Planning Commission

Staff Report

Case No:	22-DDP-0001
Project Name:	Shepherd Springs
Location:	8016 Shepherdsville Road
Owner(s):	Utica Investments LLC
Applicant:	Denton Floyd Real Estate Group
Jurisdiction:	Louisville Metro
Council District:	24- Madonna Flood
Case Manager:	Julia Williams, AICP, Planning Supervisor

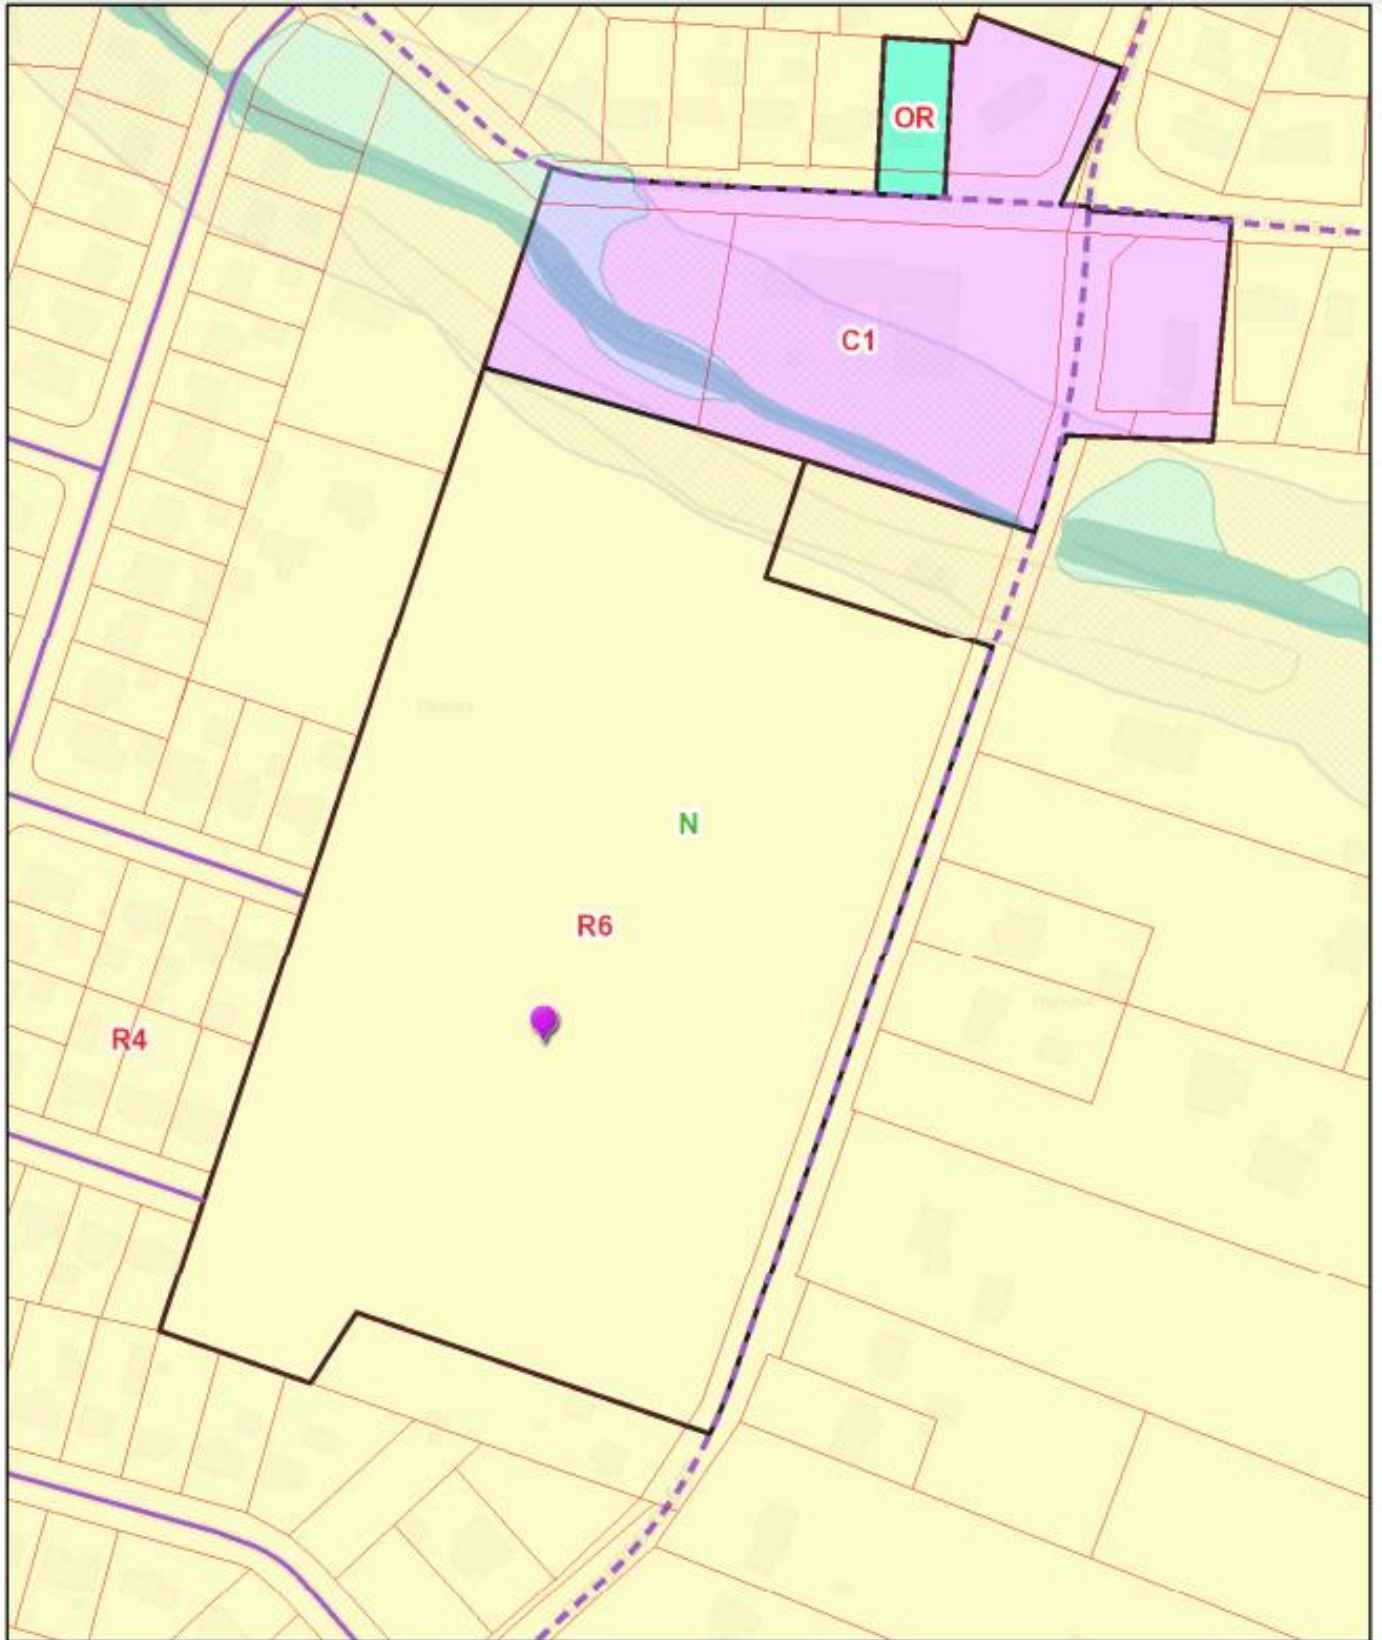
There are no proposed connections to Cedar Brook Drive and Red Cedar Way. A shared access drive that leads to the Shields property will remain.

Staff finds that the proposal meets the guidelines of the Comprehensive Plan and requirements of the Land Development Code with the exception of the lack of connection to the existing stub roads.

STAFF: Provisions for safe and efficient vehicular and pedestrian transportation within and around the development and the community have not been provided as a vehicular connection to both of the stub roads is not being provided.
